**Probandt Replacement Project
(E. Lachapelle to Oelkers)
Solicitation Number: CO-00640
Job No.: 22-4522**

**ADDENDUM 1
April 29, 2024**

MILL & OVERLAY AND STRIPING PLAN

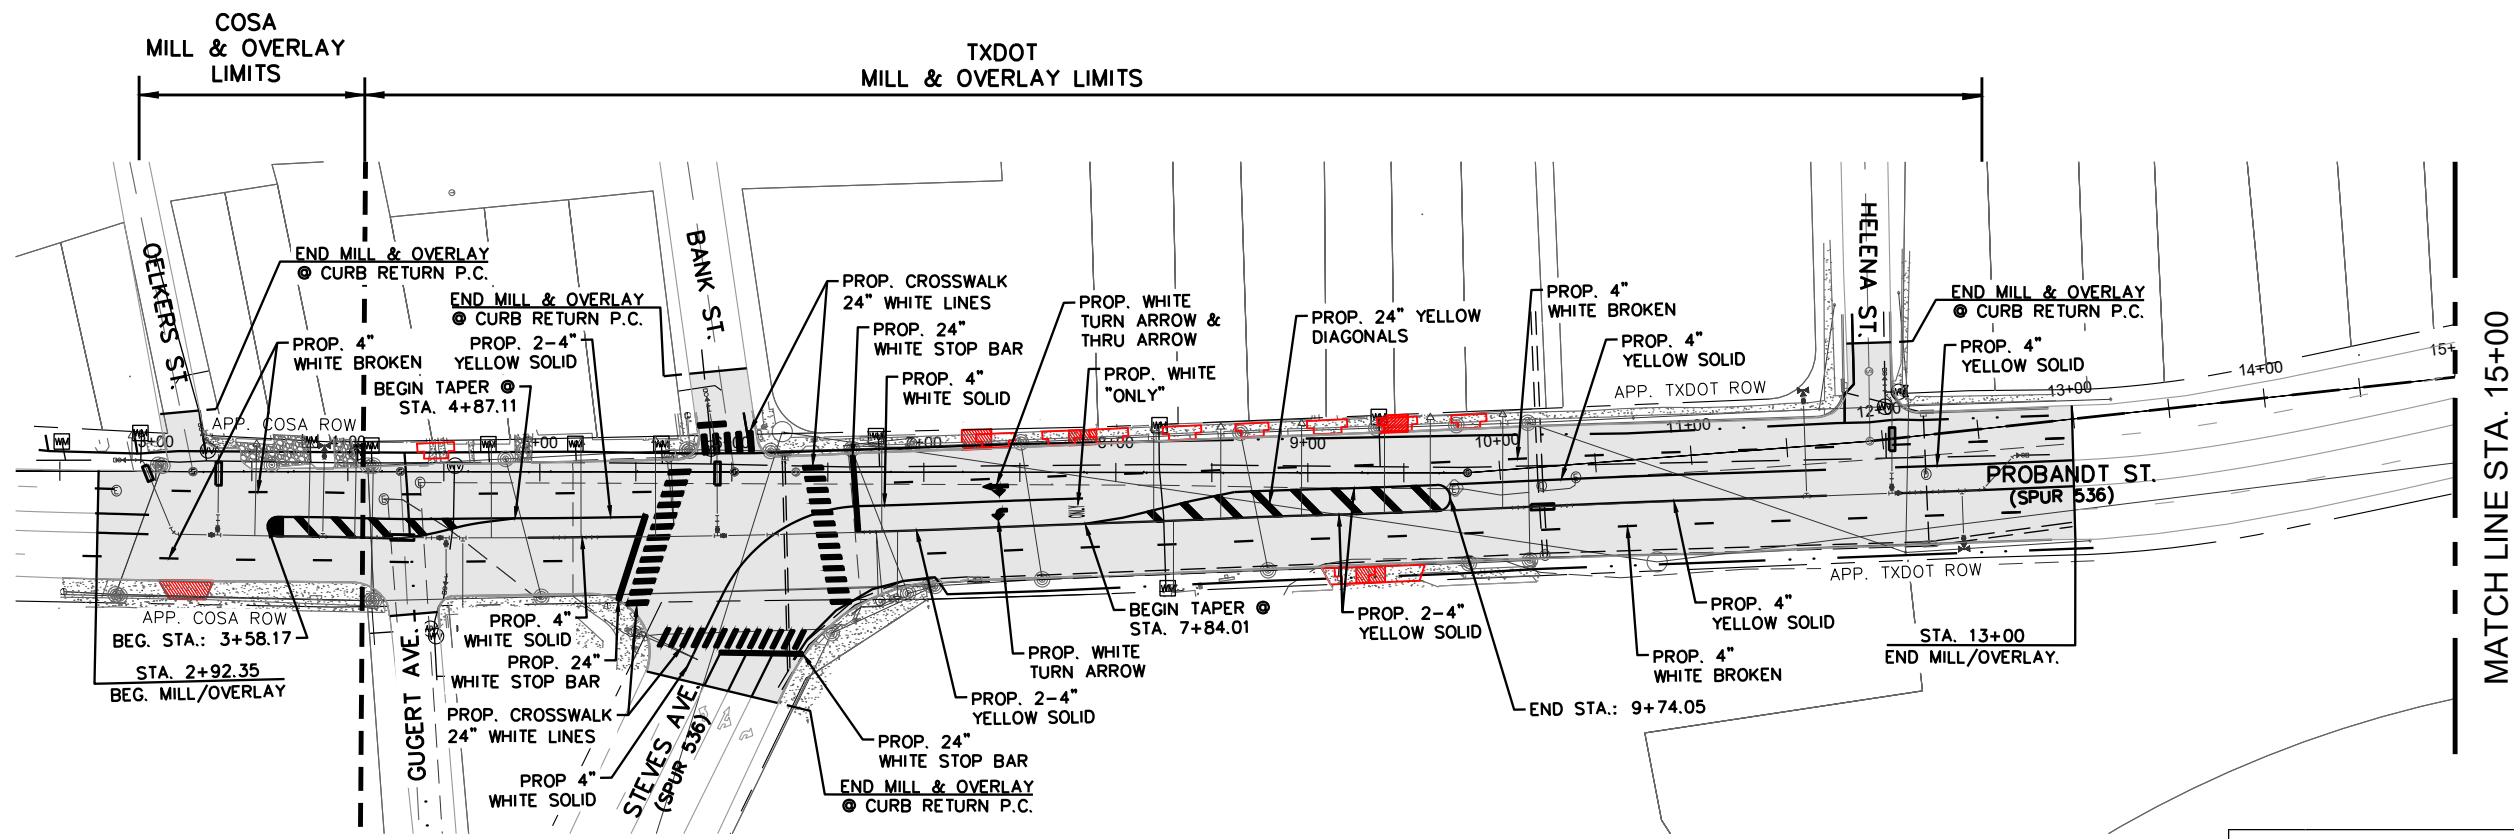
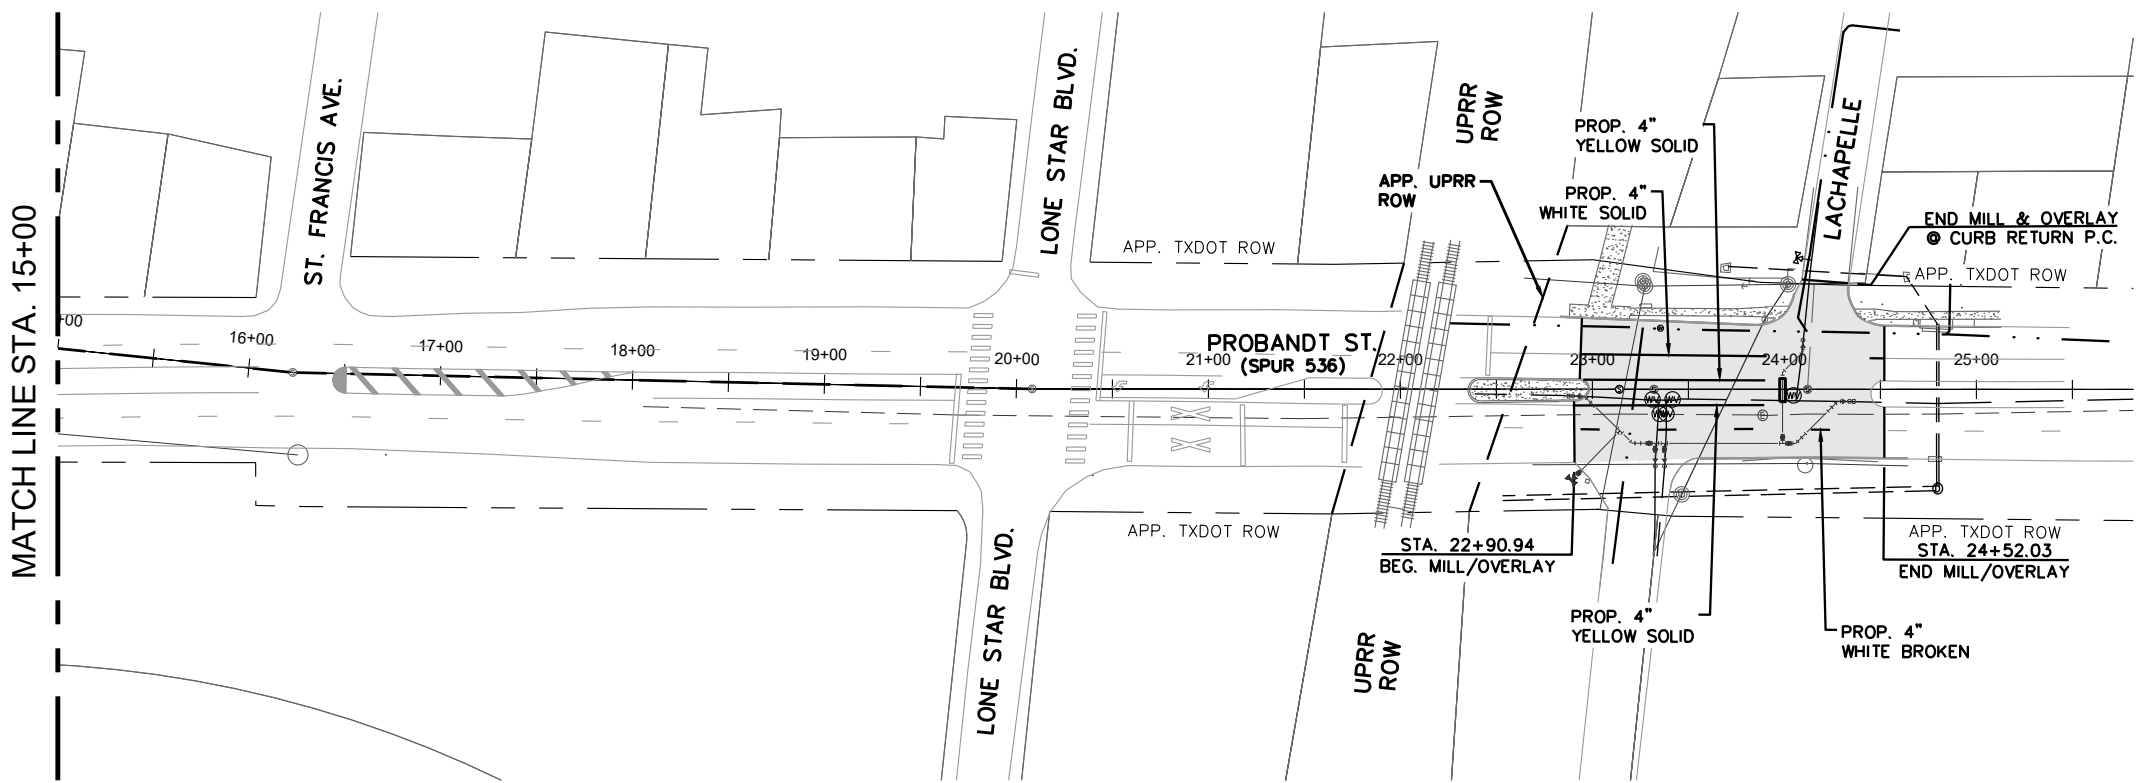
- 4. Plan sheet 7 states all utility valves are to be adjusted. Will the appropriate bid item be added for this work?**

Sheet 7- Mill & Overlay and Stripping Plan

Yes, a bid item and associated quantities for utility valve adjustments were added to the bid form as Item 826. Please refer to #1 Changes to Specifications in this Addendum.

Revision to SAWS Standard Specification Item No. 826 to clarify that adjustments of valves are applicable for both the water and gas valves.
